SERVICE BULLETIN

N° **139-605**

REV. : A - March 9, 2021

ATA 32 - ELECTRICAL WHEEL BRAKE CABLE ASSY REPLACEMENT

Figure 1

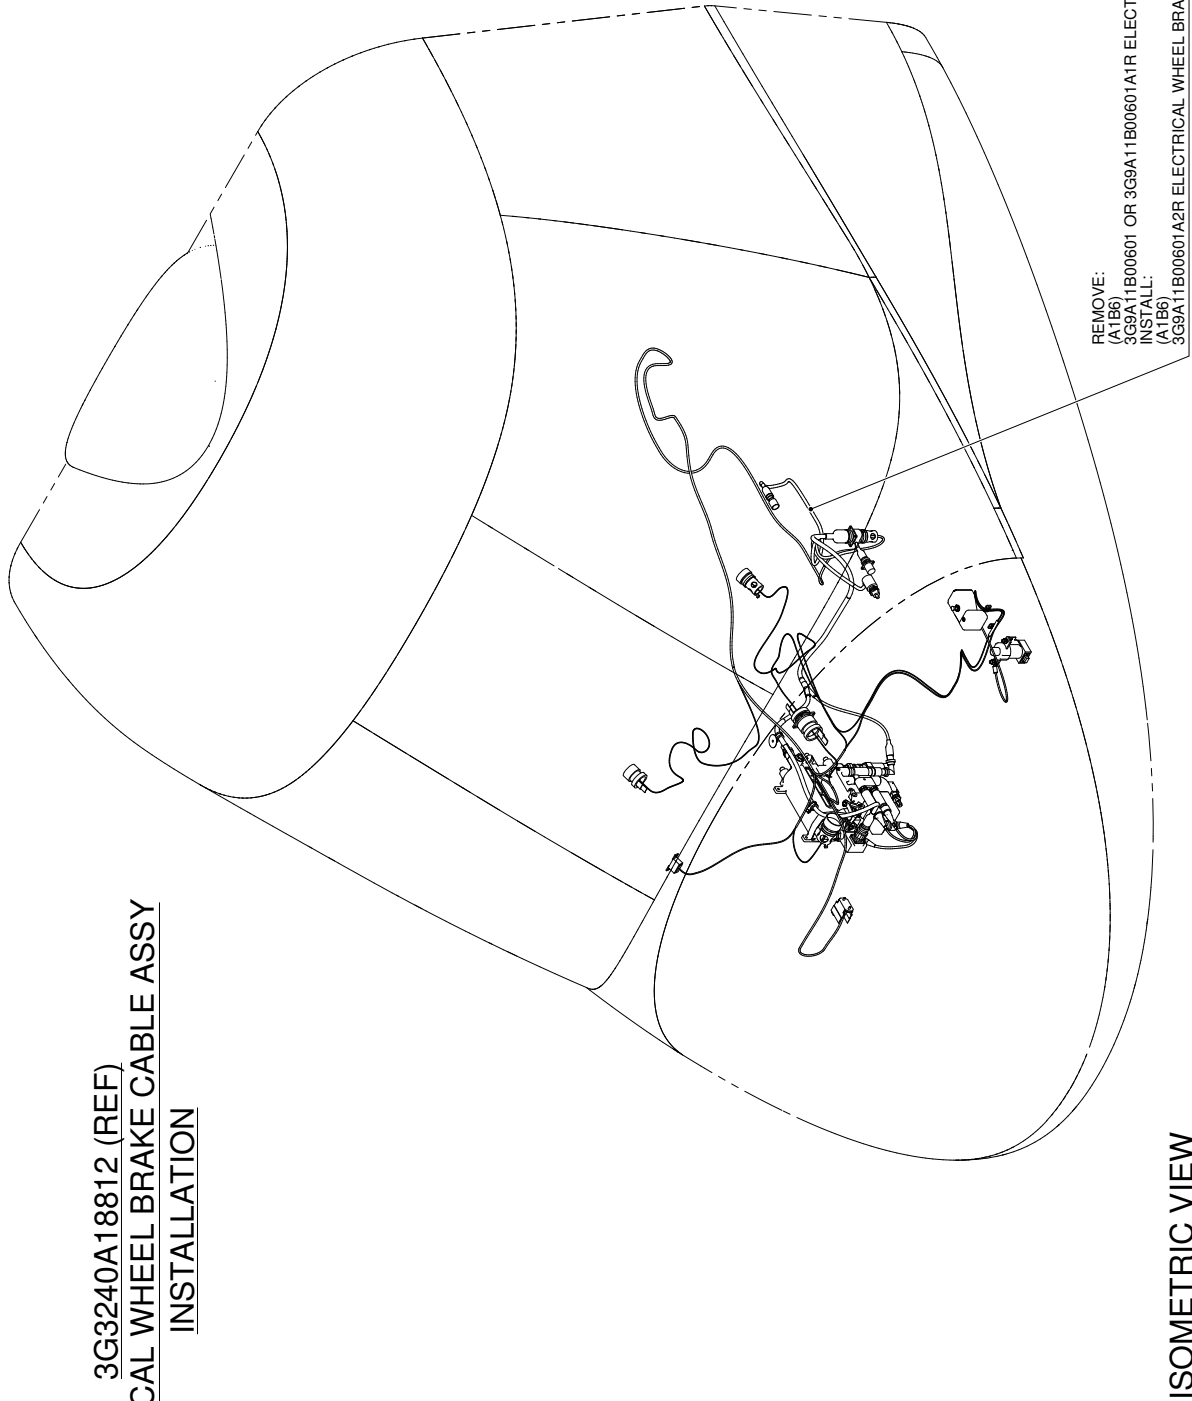
3. In accordance with AMP DM 39-A-06-41-00-00A-010A-A and with reference to Figures 1 and 2, gain access to the area affected by the replacement and perform the following procedure:
 - 3.1 With reference to Figures 1 and 2, remove and discard the existing A1B6 electrical wheel brake C/A. Retain existing hardware for later reuse.

- 3.2 With reference to Figures 1 and 2, lay down the A1B6 electrical wheel brake C/A P/N 3G9A11B00601A2R following the existing route and secure the cables using the existing hardware.

Figure 2

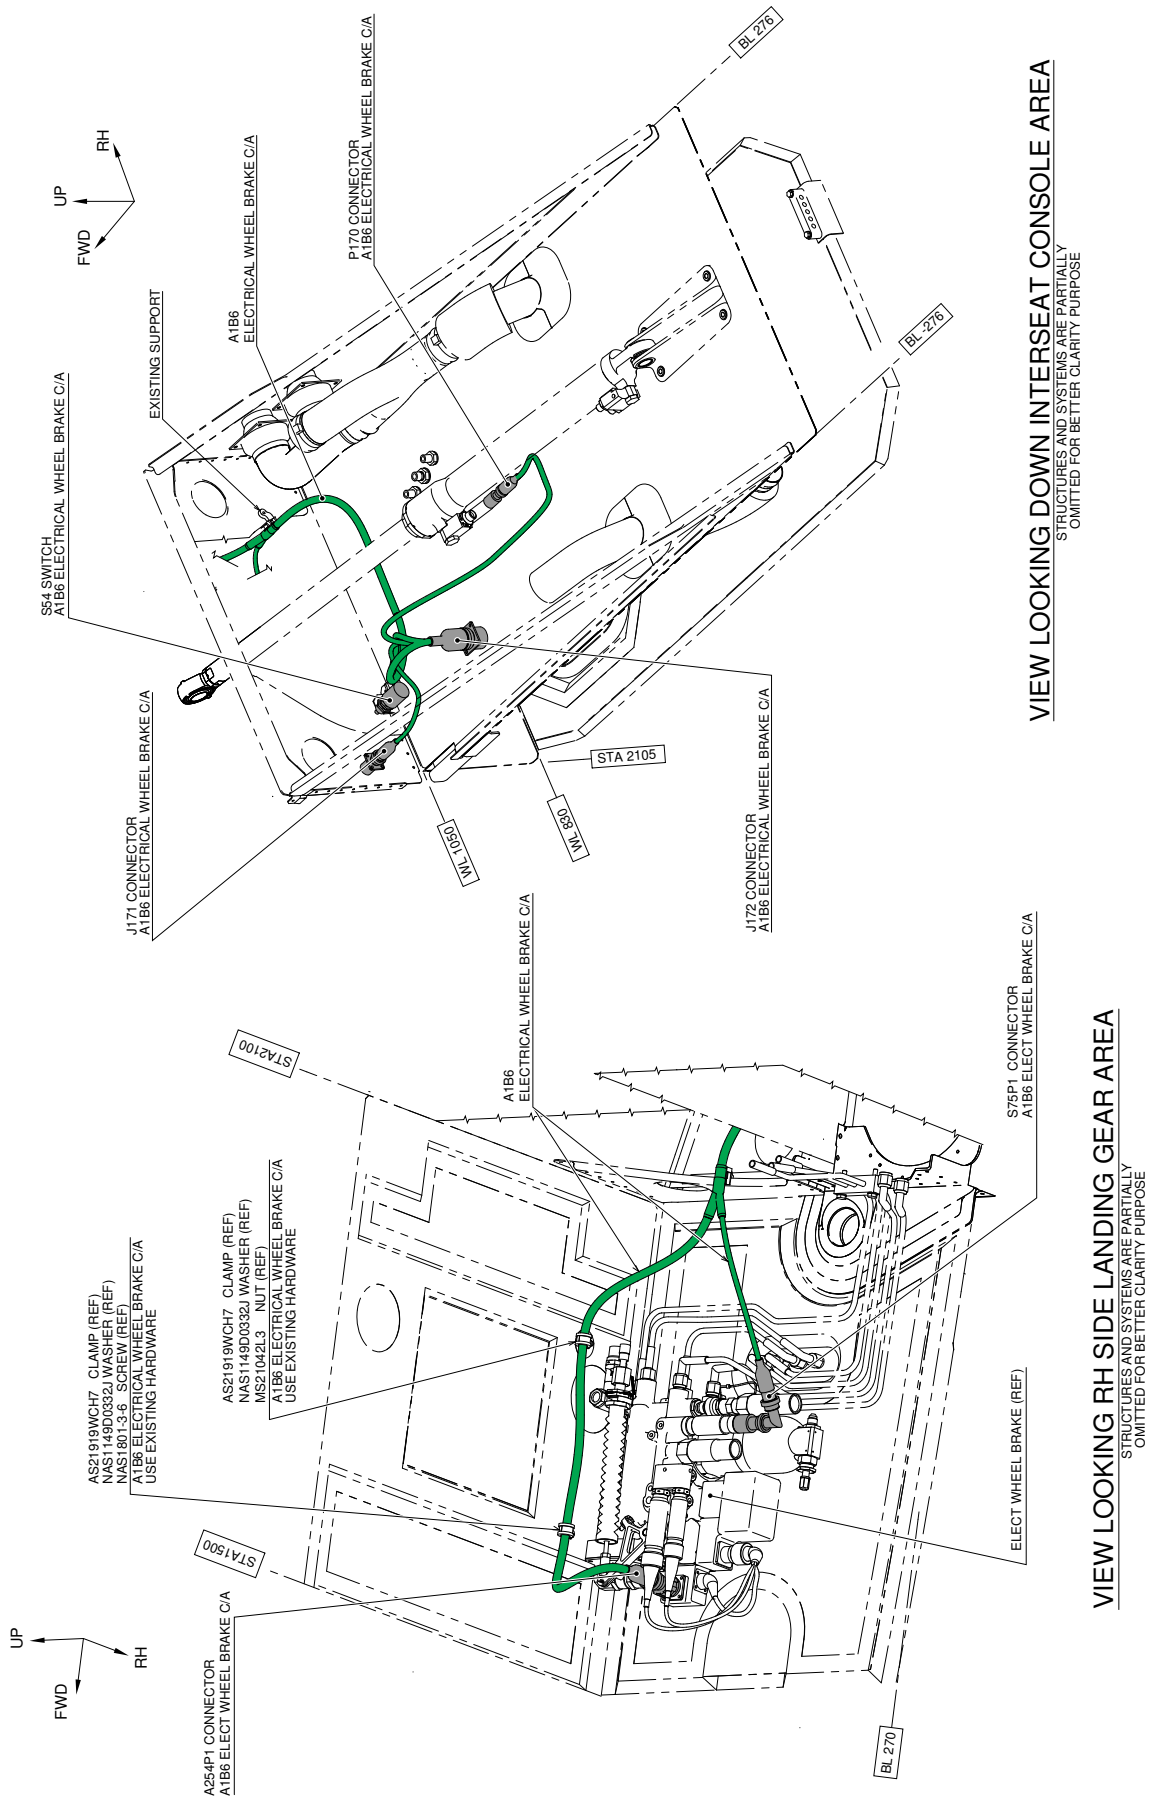
- 3.3 With reference to Figures 2 and 7, if the helicopter is equipped with NLG doors kit P/N 3G5280F00111, install a heatshrinkable elbow boot P/N A574A01-01 or P/N A574A02-01 on AP254P1 connector in lieu of the straight boot, in order to avoid any interference between connector boot and NLG actuator.
- 3.4 With reference to Figure 2, connect pressure switch LH connector S75P1, WBPEM connector A254P1, sectioning connectors J172, J171 and P170 of the A1B6 electrical wheel brake C/A P/N 3G9A11B00601A2R.
4. With reference to Figure 2 and to Figure 8 wiring diagram, check the modification made according to the following procedure:
 - 4.1 Disconnect P172 connector from J172 connector.
 - 4.2 Press switch S54.
 - 4.3 Make sure that there is continuity between pin E and pin F of J172 connector when switch S54 is activated.
 - 4.4 Connect P172 connector to J172 connector.

Figure 3

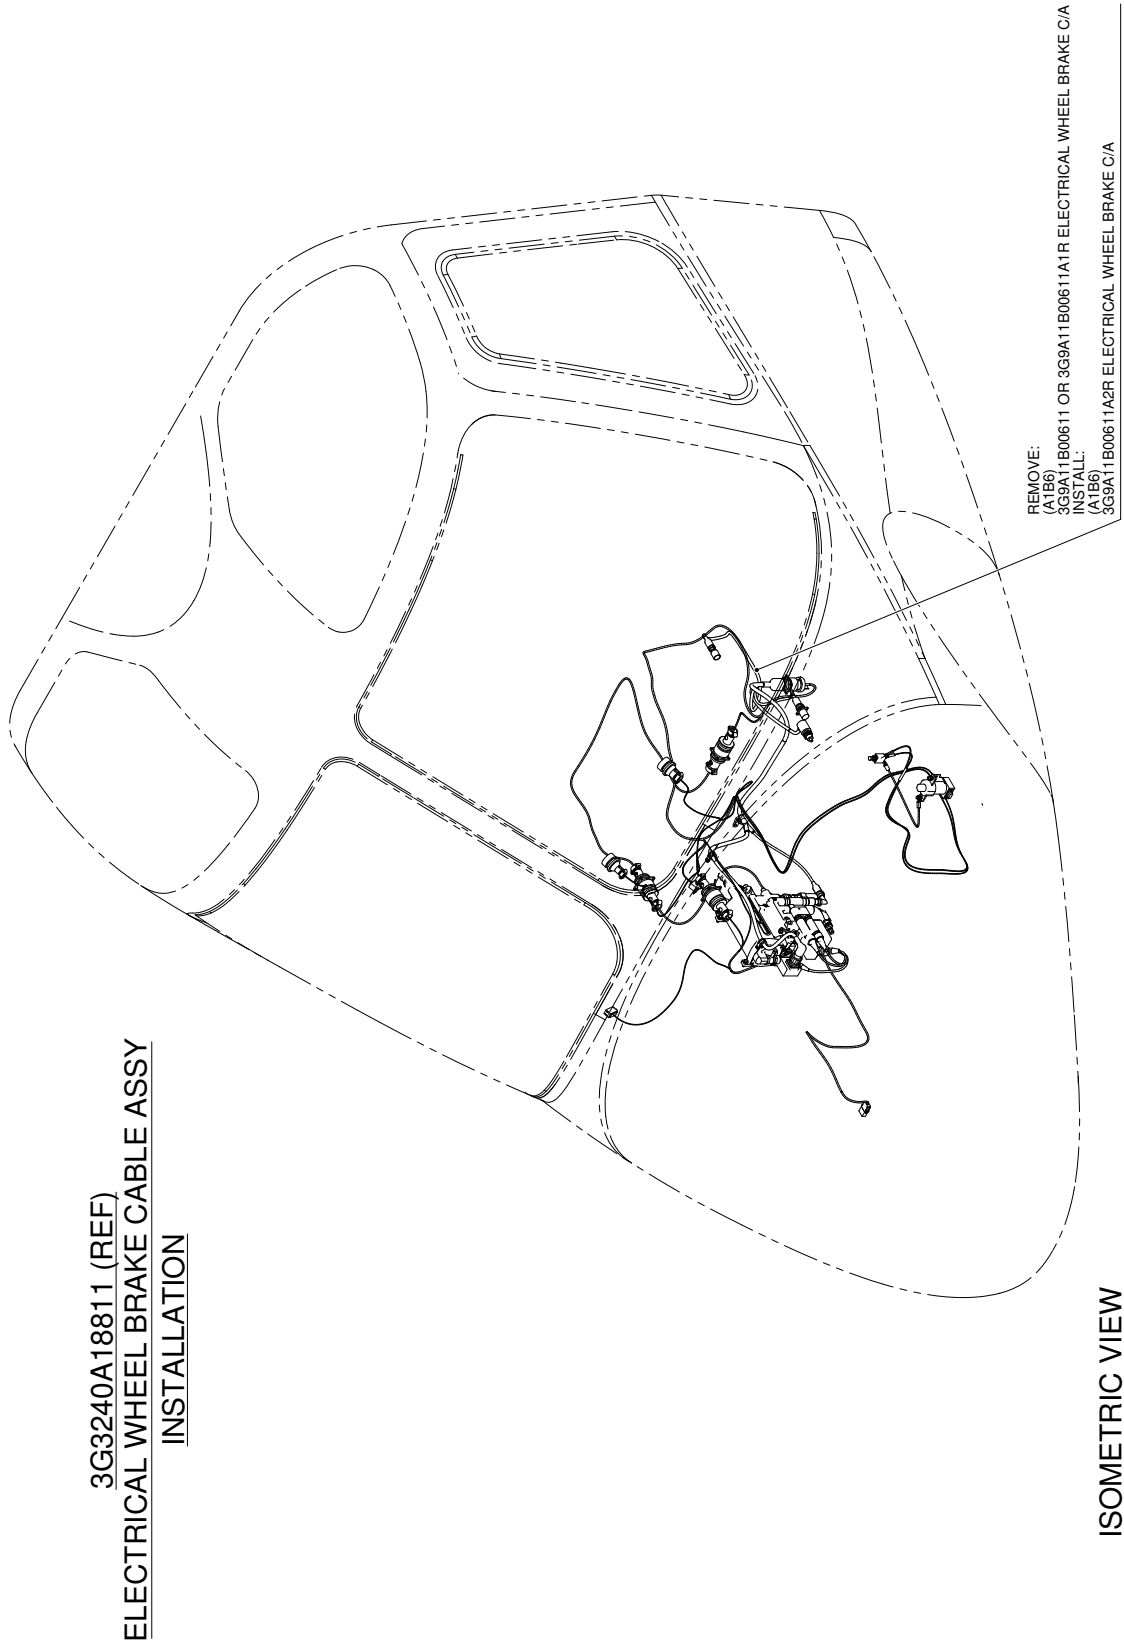
5. In accordance with AMP DM 39-A-06-41-00-00A-010A-A and with reference to Figures 3 thru 6, gain access to the area affected by the replacement and perform the following procedure:
 - 5.1 With reference to Figures 3 thru 6, remove and discard the existing A1B6 electrical wheel brake. Retain existing hardware for later reuse.

Figure 4

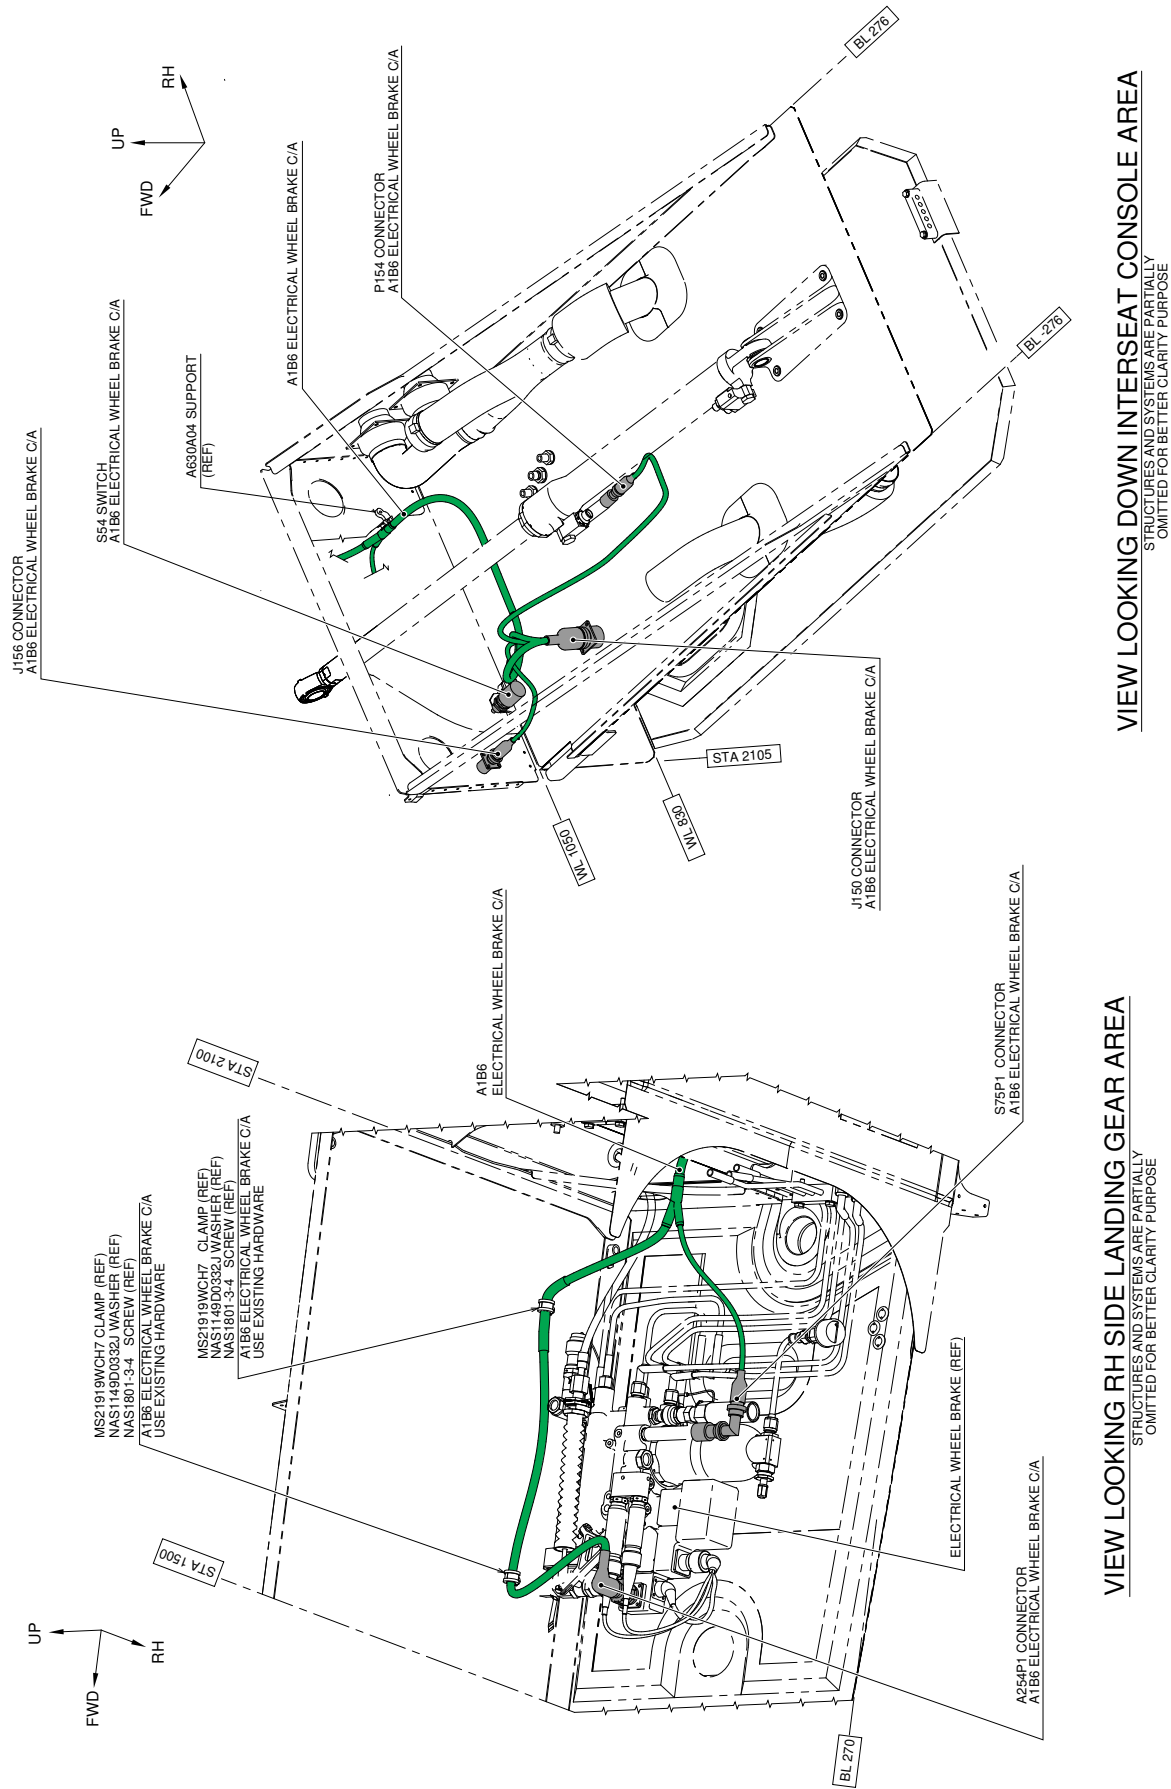
- 5.2 With reference to Figures 4 or 6, lay down the A1B6 electrical wheel brake C/A P/N 3G9A11B00611A2R following the existing route and secure the cables using the existing hardware.

- 5.3 With reference to Figures 4 (or 6) and 7, if the helicopter is equipped with NLG doors kit P/N 3G5280F00111, install a heatshrinkable elbow boot P/N A574A01-01 or P/N A574A02-01 on AP254P1 connector in lieu of the straight boot, in order to avoid any interference between connector boot and NLG gear actuator.
- 5.4 With reference to Figures 4 or 6, connect pressure switch LH connector S75P1, WBPEM connector A254P1, sectioning connectors J150, J156 and P154 of the A1B6 electrical wheel brake C/A P/N 3G9A11B00611A2R.

Figure 8

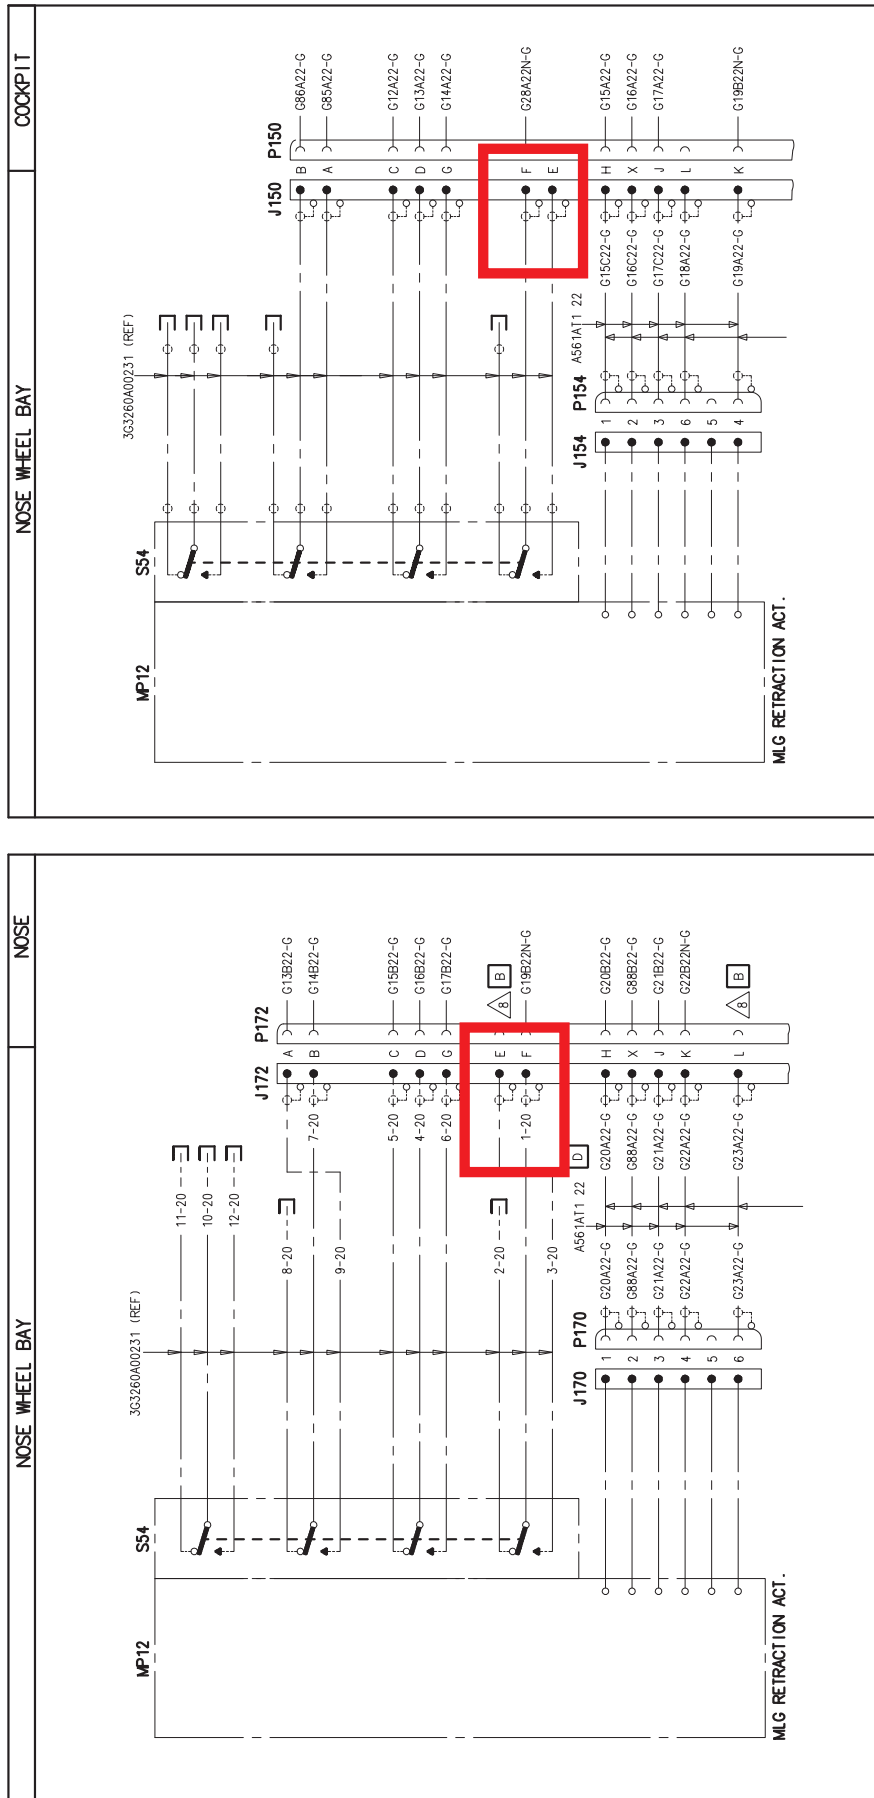
- 5.7.2 Stow wire ID G153C20-G using an applicable cap.
- 5.8 Connect connector P150 to connector J150.
6. With reference to Figure 4 (or 6) and to Figure 8 wiring diagram, check the modification made according to the following procedure:

- 6.1 Disconnect P150 connector from J150 connector.
 - 6.2 Press switch S54.
 - 6.3 Make sure that there is continuity between pin E and pin F of J150 connector when switch S54 is activated.
